## HISTORIC AND DESIGN REVIEW COMMISSION

**HDRC CASE NO:** 2020-259  
**ADDRESS:** 222 W MULBERRY AVE  
**LEGAL DESCRIPTION:** NCB 3002 BLK 4 LOT 5, E 20 FT OF 4 & W 5 FT OF 6  
**ZONING:** R-5, H  
**CITY COUNCIL DIST.:** 1  
**DISTRICT:** Monte Vista Historic District  
**APPLICANT:** Ronnie Suarez/Integrity Roofing and Siding  
**OWNER:** Francisco Gonima/GONIMA FRANCISCO ALEJANDRO  
**TYPE OF WORK:** Reroofing from shingle to metal  
**APPLICATION RECEIVED:** June 02, 2020  
**60-DAY REVIEW:** Not applicable due to City Council Emergency Orders  
**CASE MANAGER:** Huy Pham

### REQUEST:

The applicant is requesting a Certificate of Appropriateness for approval to replace the red composition shingle roof with a red standing seam metal roof.

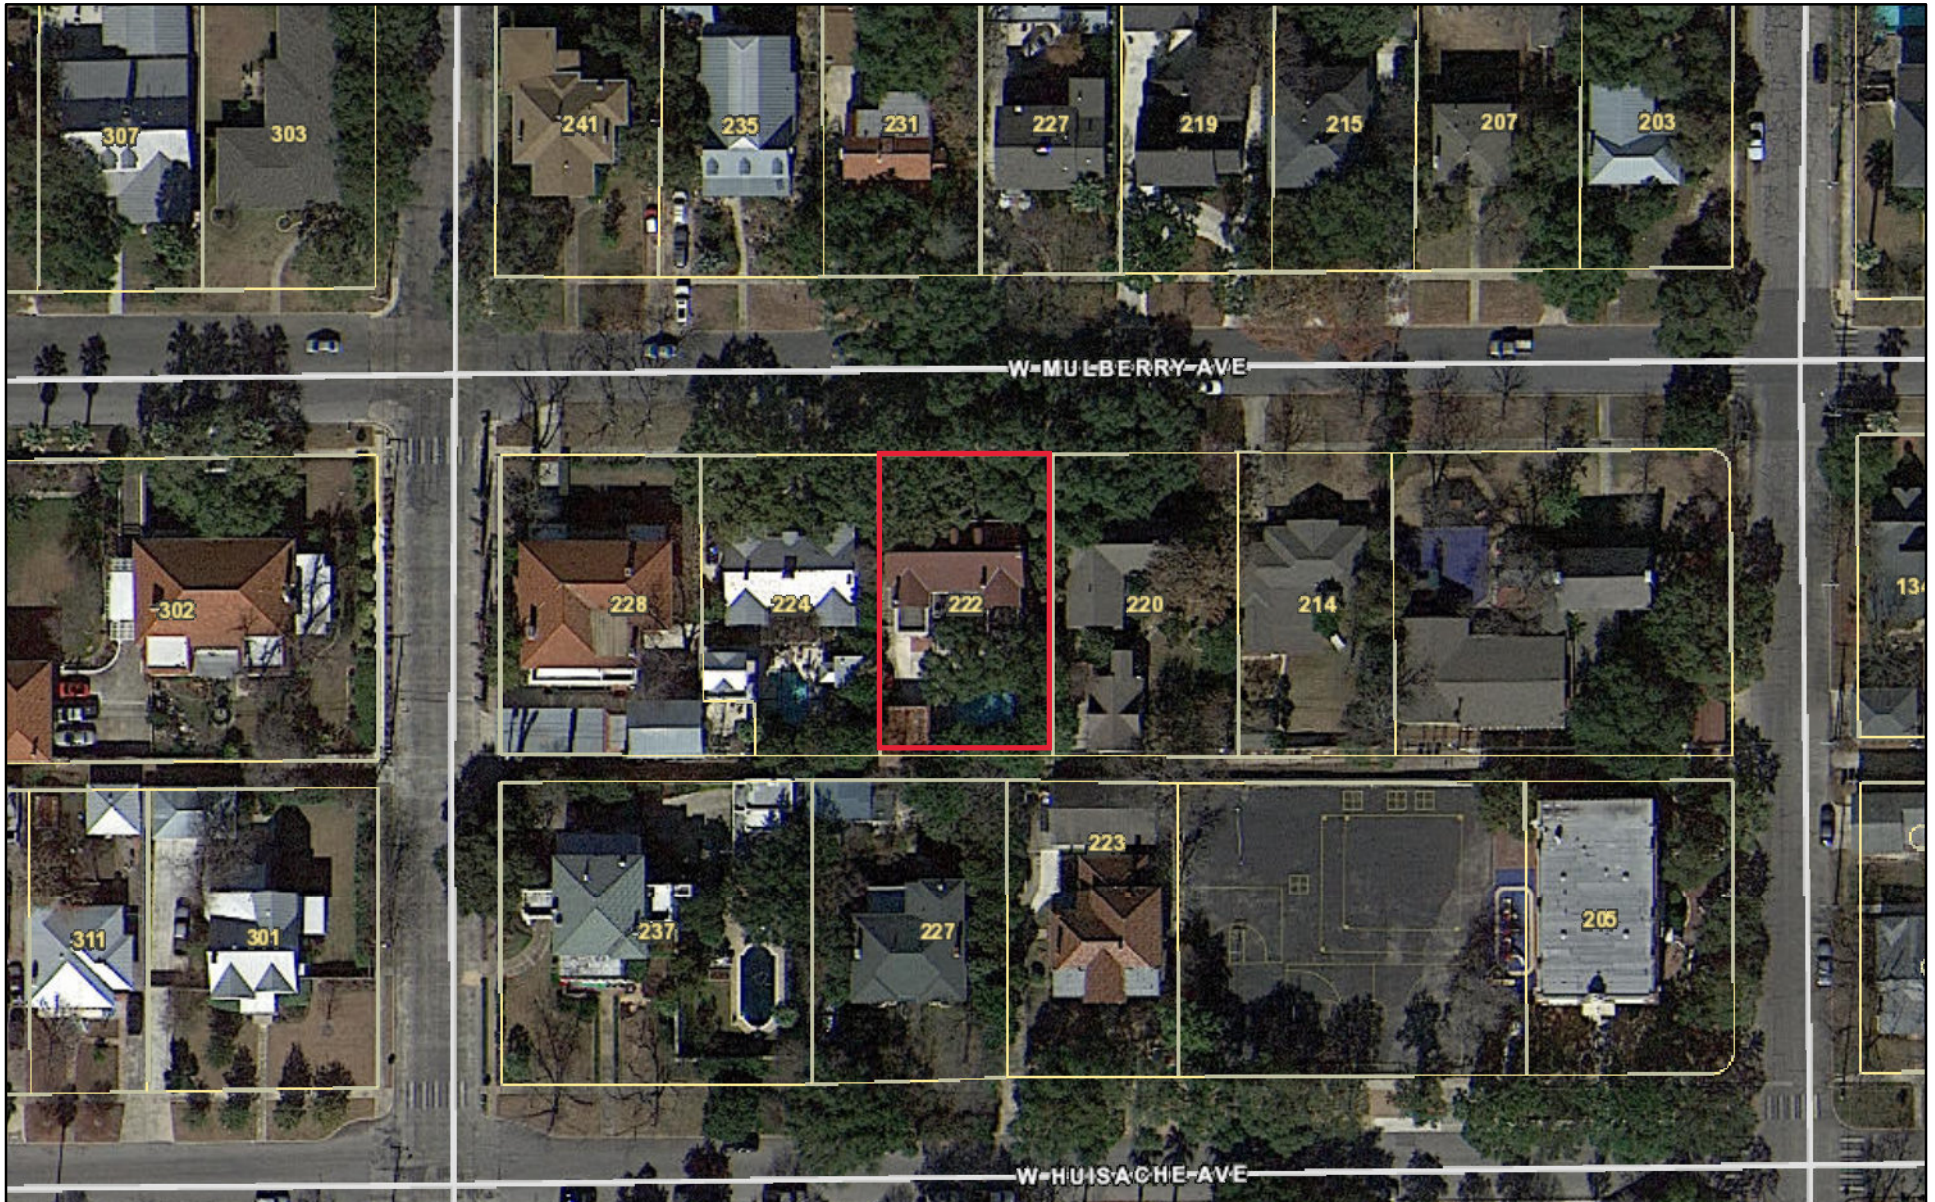
- a. The primary historic structure at 222 W Mulberry was designed by Atlee B. Ayres Sr. in the Italianate style, was constructed circa 1920, first featured on the 1951 Sanborn map, and contributes to the Monte Vista Historic

District. The two-and-a-half-story, single-family structure features a symmetrical configuration, stucco siding, dentil molding, and a primary turned gable with front dormers and rear-facing gables.

- b. **ROOF REPLACEMENT** – The applicant has proposed to replace the existing red composition shingle roof with a new red standing seam metal roof. Per the Guidelines for Exterior Maintenance and Alterations 3.B.vi., applicants should use metal roofs on structures that historically had a metal roof or where a metal roof is appropriate for the style or construction period. Per the 1951 Sanborn map, staff finds that the structure originally featured a non-combustible material such as metal, slate, or tile. Additionally, the applicant has provided supporting material that states the structure at 222 W Mulberry was “built in tile and finished in cream, white and cement stucco, with dark red metal roof” concurrent with the structure at 224 W Mulberry, which was also designed by Atlee B. Ayres Sr. and still features a standing seam metal roof. While metal roofs are atypical to Italianate style structures, staff finds that the request is appropriate given the historic documentation and similar conditions on the 200 block of W Mulberry and the Monte Vista Historic District. If a standing seam metal roof is approved, the applicant should adhere to the standard specifications for standing seam metal roofs.

Staff recommends approval based on finding b with the stipulation that the new metal roof feature the standard specifications:

- *Panels that are 18 to 21 inches in width*
- *Seams are 1 to 2 inches in height*
- *Ridges are to feature a double-munch or crimped ridge configuration; no vented ridge caps or end caps are allowed.*
- *Roof color will feature a standard galvalume finish or match the existing historic roof.*
